NORTHDRIDGE ESTATES

RE: S/D 96-60, Final Plat of the NORTHRIDGE ESTATES ADDITION

CASE NUMBER: S/D 96-60 - NORTHRIDGE ESTATES ADDITION

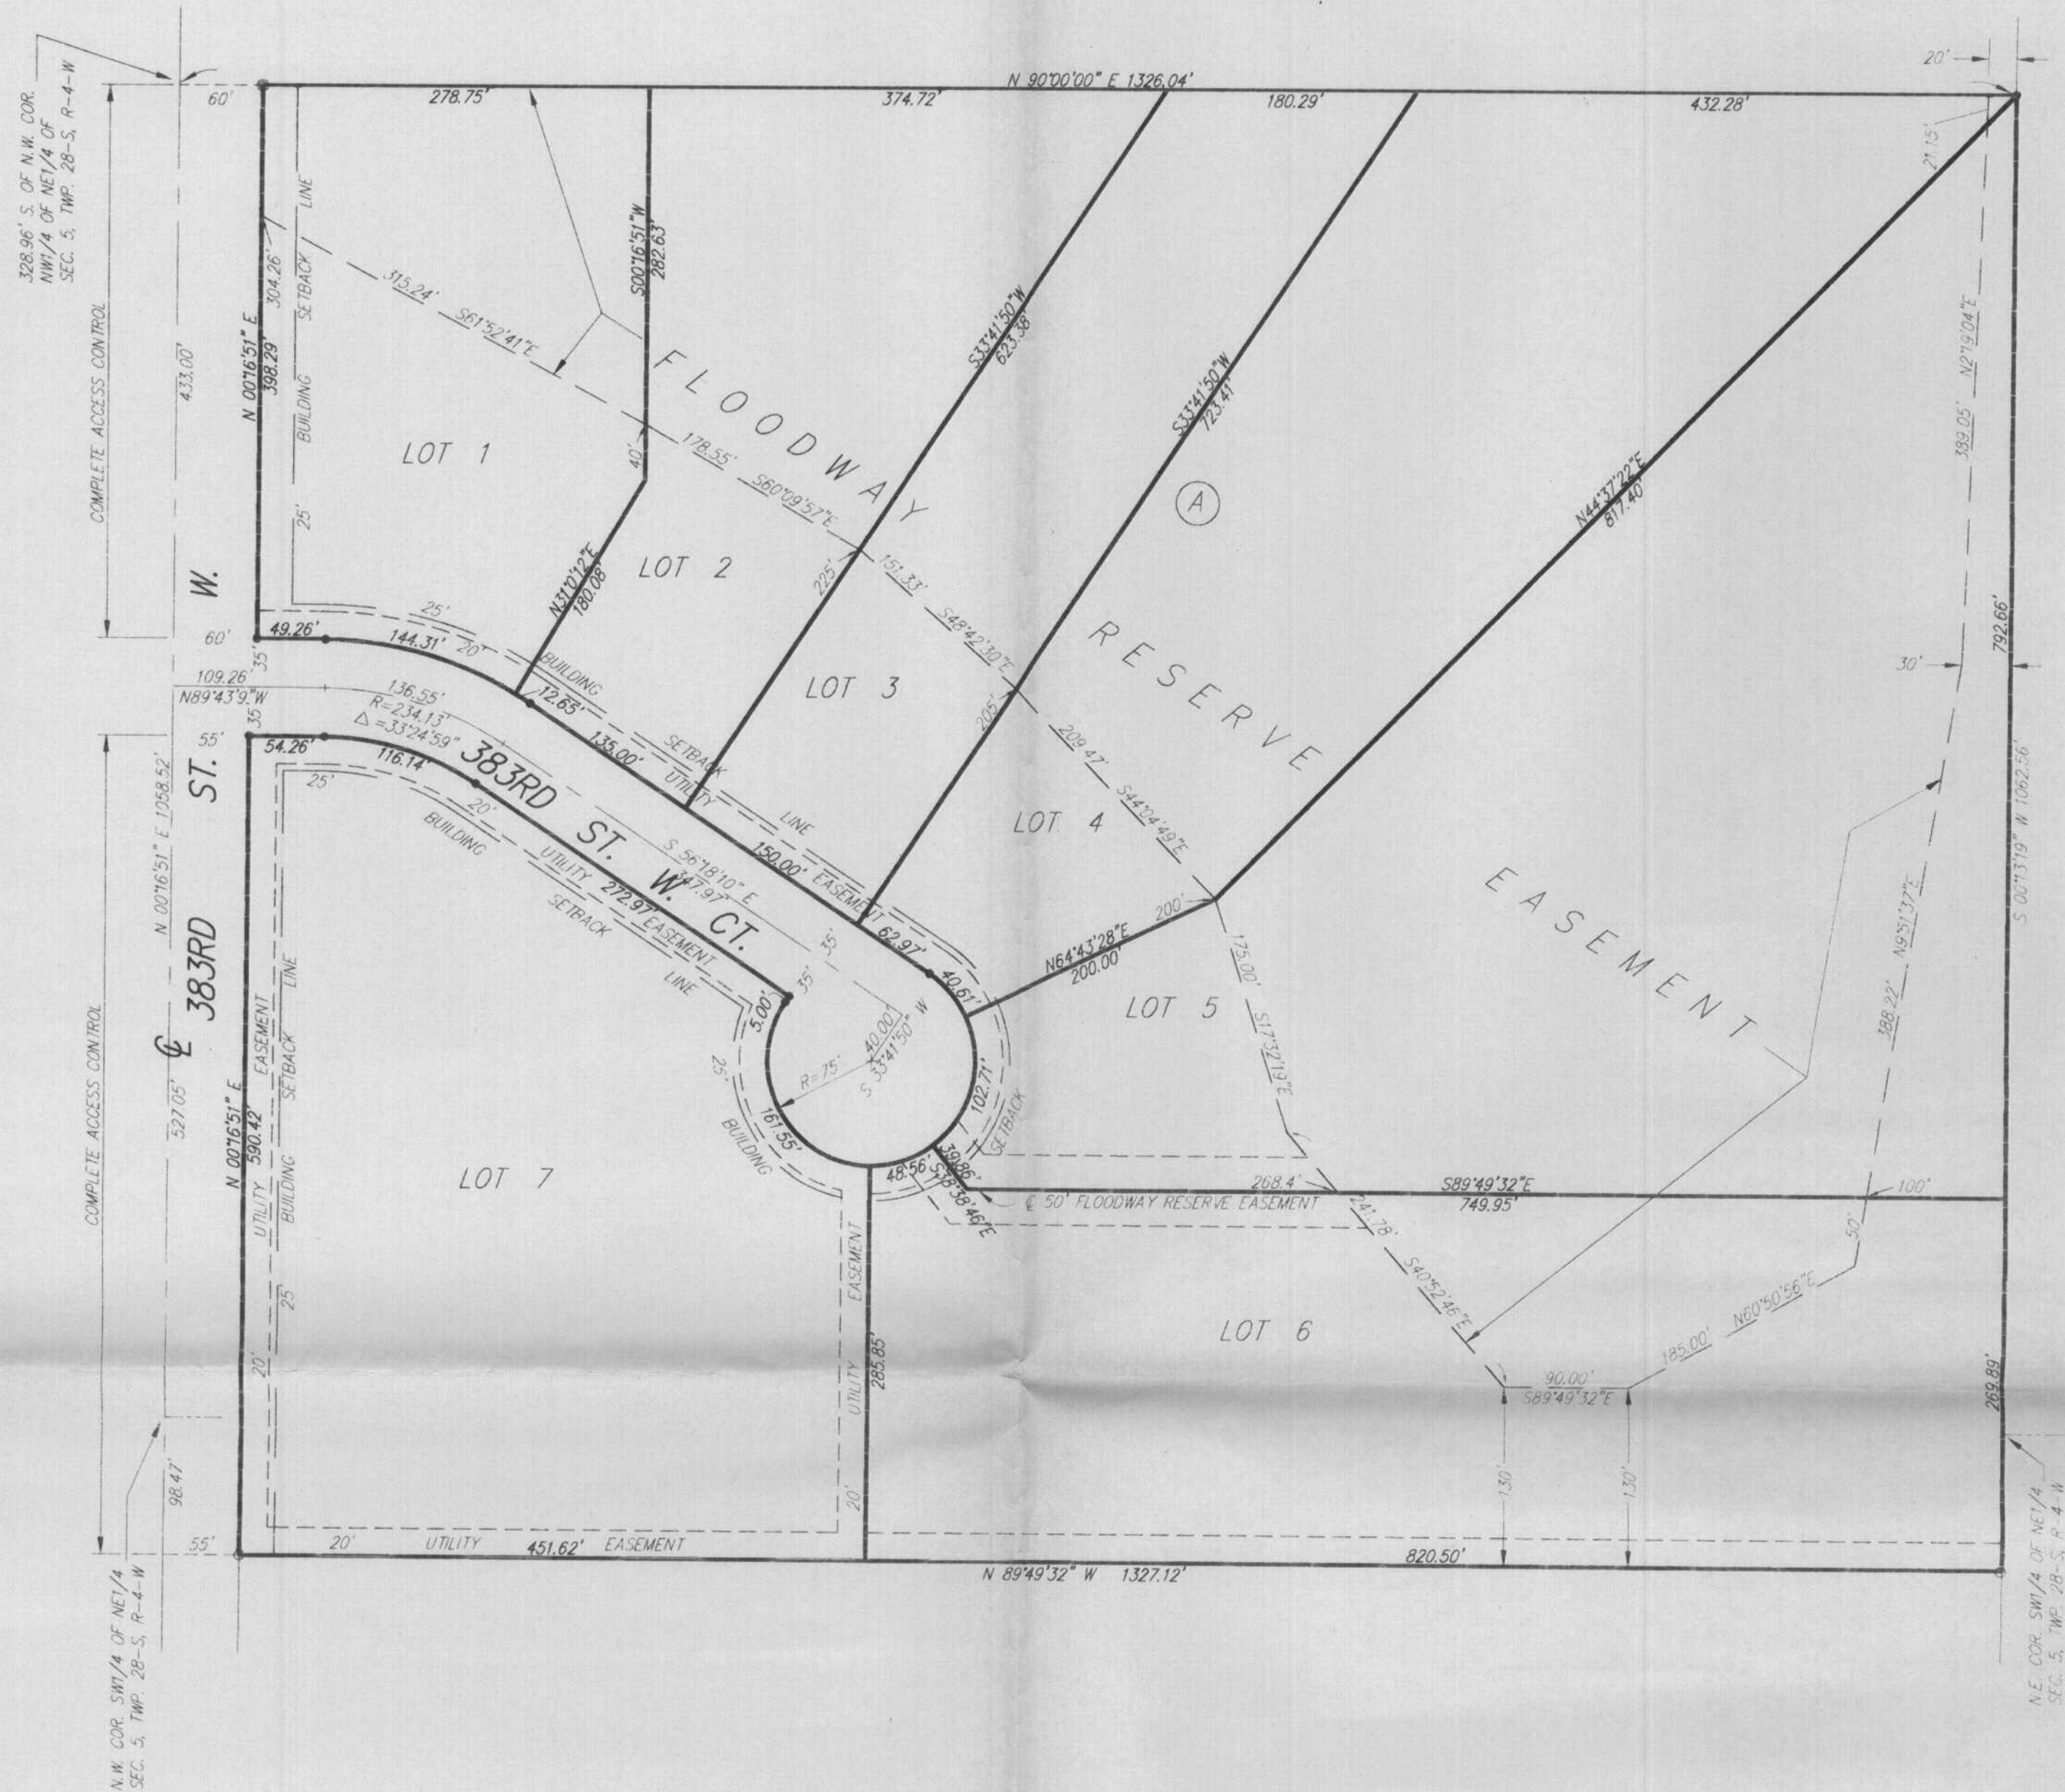
However, Lots 7 and 8 shall be combined into one lot with either septic or lagoon sanitary sewer used if allowed by the Health Department. For the other lots of this plat, because of limited usable area, a covenant as required by the Health Department shall be provided for recording which clearly specifies that restrictions are involved for the location of homes, related uses and on-site sanitary sewer for these lots. This covenant shall also

note that a site development plan shall be submitted to Health as part of the on-site sanitary sewer application and will be subject to Health Department approval. Also, a note shall be placed on the face of the plat noting the filing of such a covenant. This covenant needs to be reviewed and approved by the Health Department then submitted to Planning for recording with the plat.

D. During review of the preliminary plat, it was stated and approved that since Cheney Spur is a major north-south street connecting U.S. 54 and Cheney, all lots adjacent to that street shall be platted with complete access control. Also that a guarantee shall, therefore, be provided to close the opening shown at the southwest corner of Lot 7.

However, this final plat is continuing to show an access opening to 383rd Street West from Lot 7. At this time, apparently, an existing use on what is being platted as Lot 6, has driveway access out to 383rd Street West. Also, a use to the south appears to be using this opening for access. The plat is indicating a 40-foot easement to the interior cul-de-sac, which would apparently be to the benefit of the use south of the site. Also, the uses on Lot 6 would be expected to use the interior street when it is constructed. Consequently, the opening to 383rd Street West, appears to be a temporary need until such time as the interior street is constructed.

Therefore, the opening from Lot 7 only be allowed as temporary access. A contingent dedication of complete access control by separate instrument shall be provided and words to that effect shall be placed in the plat's text. The contingency itself stating that complete access control to 383rd Street West from Lot 7 will occur when 383rd Street West Ct. is constructed.

not shown
F. The 40-foot ingress and egress easement along the west line of Lot 6, if created by separate instrument, needs to have indicated the recording information for the easement on the plat. Unless this easement is for a public purpose, its creation (as a private type easement) through platting is not appropriate.

- O. As noted by County Engineering during the Subdivision Meeting of November 7, 1996, the term "Easement" needs to be deleted from the area shown as a "Floodway Reserve" on the face of the plat. Also, the plat's text shall be amended to delete reference to an easement when associated with the Floodway Reserve. Further, Lots 3, 4, 5 and 6 shall indicate a minimum building pad elevation of 1364'.
